DEPARTMENT OF MECHANICAL ENGINEERING  
THE UNIVERSITY OF TEXAS AT AUSTIN

Ref: Facility License R-129, Docket 50-602  
ANSI/ANS 15.1, *The Development of Technical Specifications for Research Reactors*

Subject: Requested changes to Section 6.0 of Technical Specifications

#### **6.1.1 Structure**

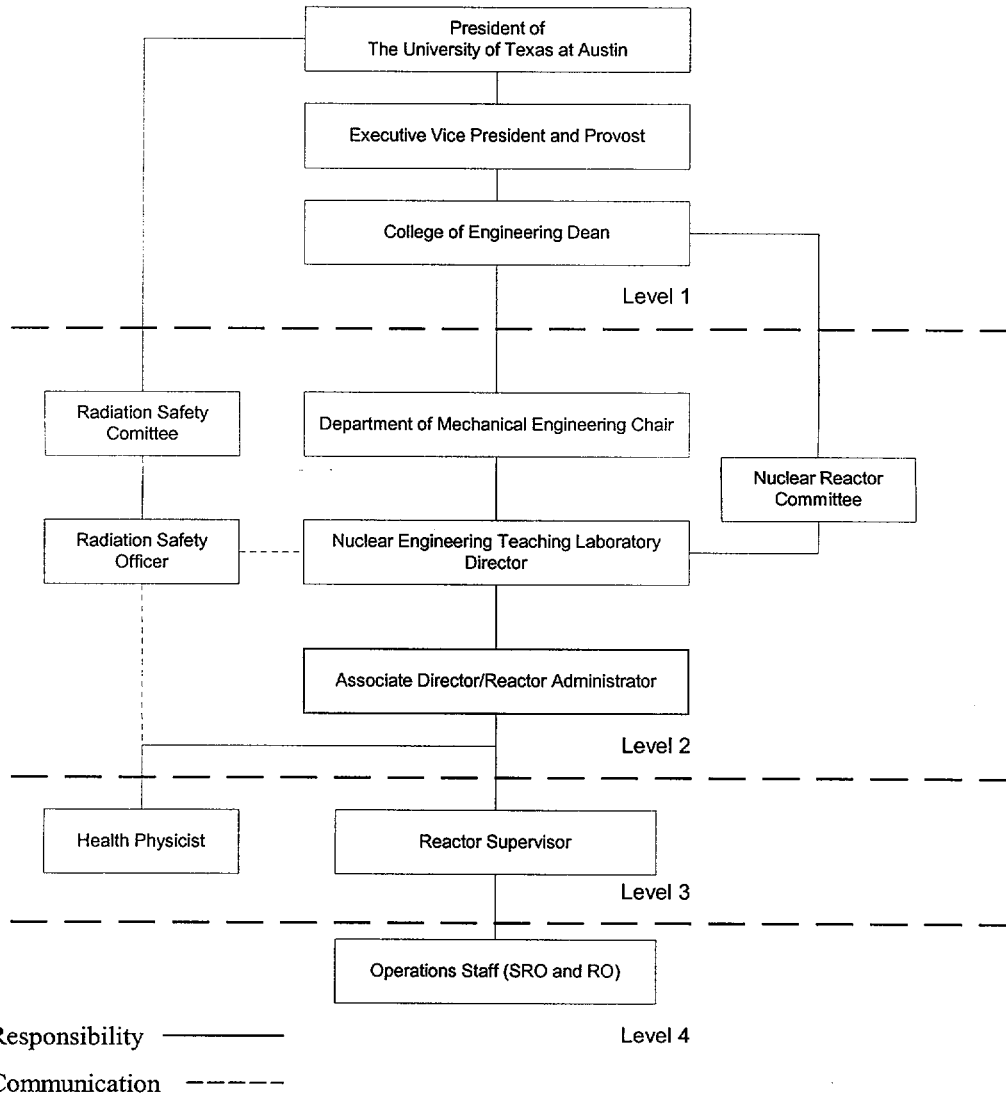
The management structure of the NETL was modified in 1999 to include the position of Associate Director. This position manages the daily facility operations and directly supervises the Reactor Operations and Health Physics groups. The Associate Director is therefore directly responsible for the facility and is delegated to act as NETL Director in his absence. An audit in November 2000 noted the Facility License, Security Plan and Emergency Plan did not address the change in NETL management structure and responsibilities and recommended immediate corrective actions. The changes are consistent with ANSI/ANS 15.1. The NETL requests the following modification to Section 6.1.1 and 6.1.2 of the Technical Specifications:

The facility shall be under the control of the Director, Associate Director or a Senior Reactor Operator. The management for operation of the facility shall consist of the organizational structure as follows:
